SP 2-201-002  
**SERVICE PROGRAM**

Xspotter Fan Shroud Replacement

Autocar has identified a defect in material thickness of certain Xspotter fan shrouds which may result in premature failure of the shroud. This Service Program provides instructions to obtain replacement parts and replace the defective shroud. Program Expires: July 31, 2014

**Figure 1**

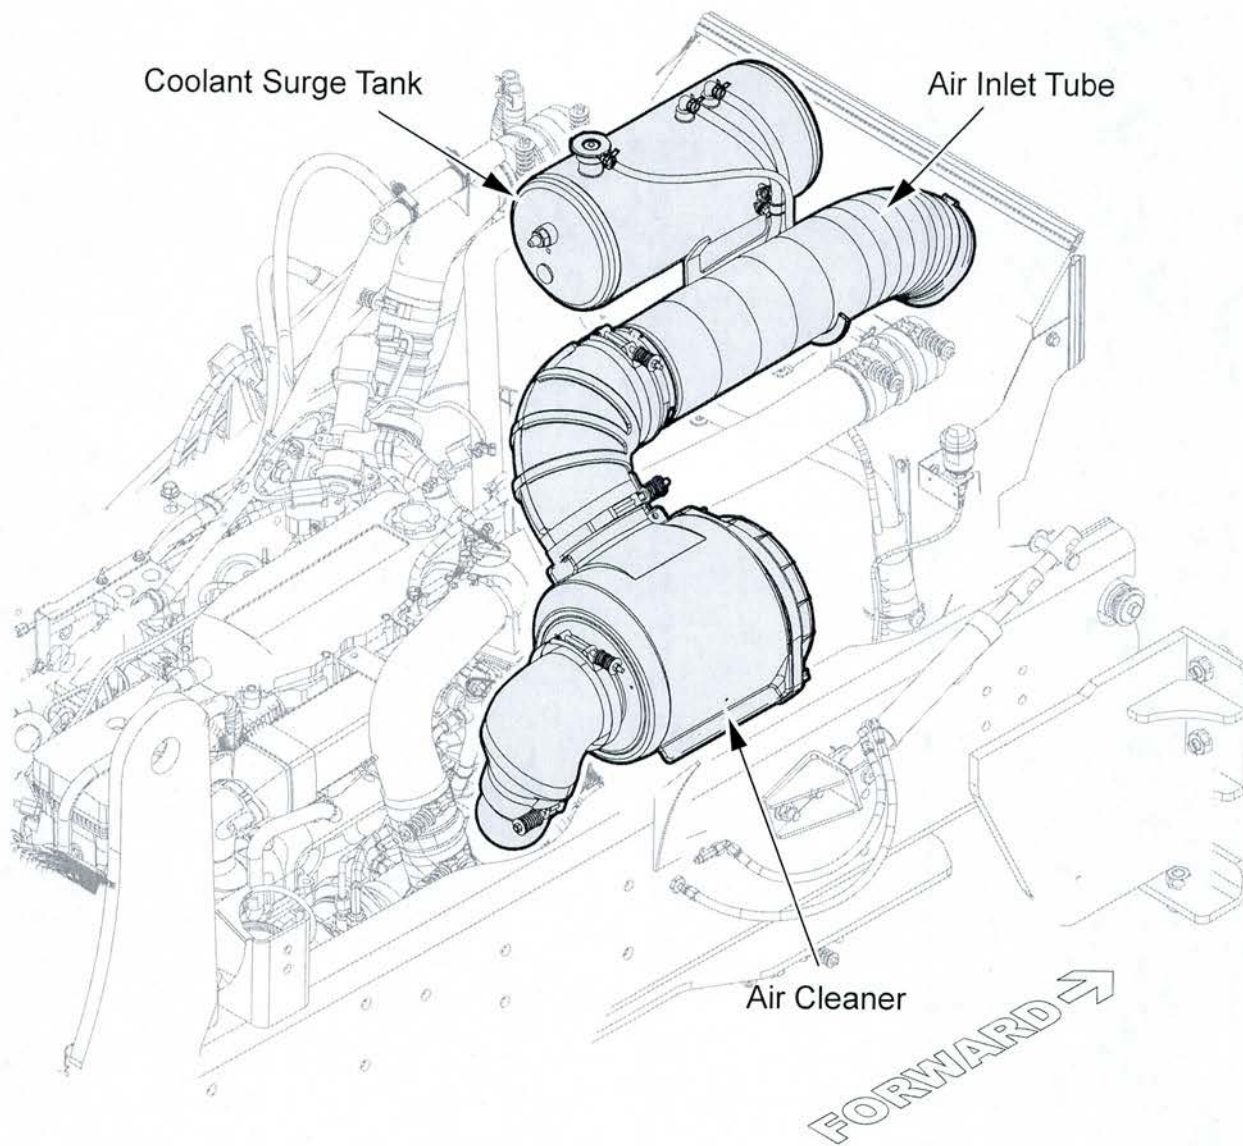
4. Remove the air inlet tube and place aside for reinstallation (see Figure 1).
  5. Remove the air cleaner and air cleaner mounting bracket and place aside for reinstallation (see Figure 1).

6. Remove the charge air cooler (CAC) inlet pipe and place aside for reinstallation (see Figure 2).
  7. Remove the coolant surge tank and place aside for reinstallation (see Figure 1).

18. Reinstall the air cleaner bracket and air cleaner that were placed aside in step 5. Tighten to 44 ft-lb (60 N-m) of torque.
  19. Reinstall the air inlet tube that was placed aside in step 4.

**Figure 2**

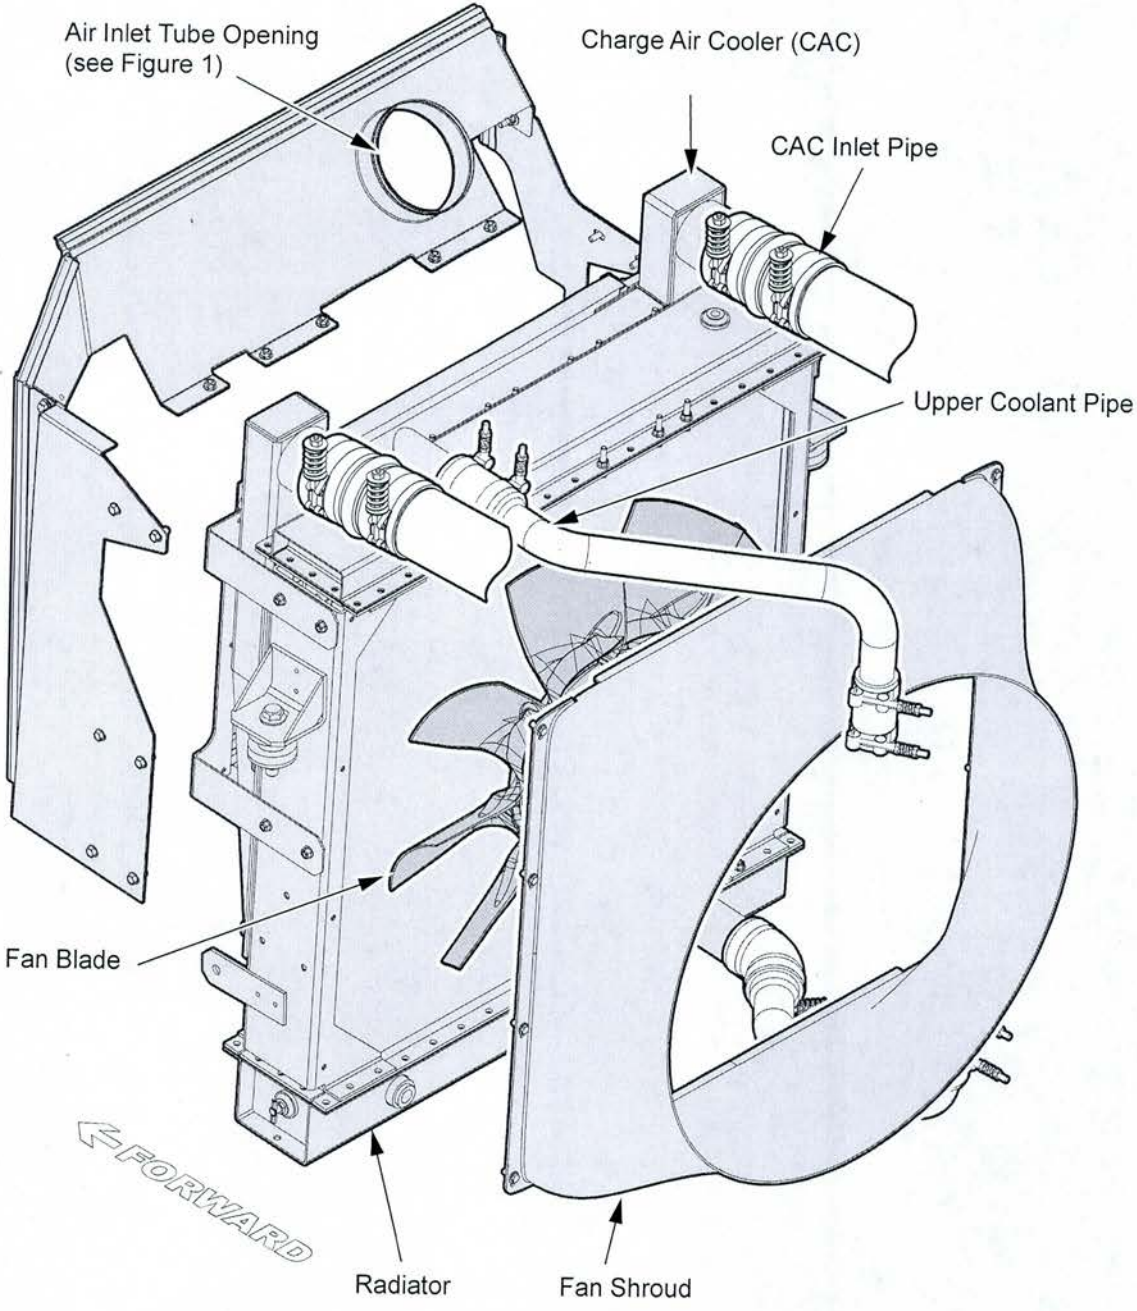
8. Remove the upper coolant pipe and place aside for reinstallation (see Figure 2).
  9. Remove the fan shroud mounting hardware and place aside for reinstallation. Move the shroud rearward to access the fan blade (see Figure 2).

10. Remove the fan blade and fan mounting studs and place aside for reinstallation (see Figure 2).
  11. Remove the fan shroud and discard (see Figure 2).

12. Place the new fan shroud (A2010180-001) into position and move it rearward to access the fan drive to reinstall the fan blade.
  13. Reinstall the fan blade and studs that were placed aside in step 10. Tighten to 295 in-lb (33 N-m) of torque.

14. Move the fan shroud into position and reinstall the fan shroud mounting hardware that was placed aside in step 9. Tighten to 143 in-lb (16 N-m) of torque.
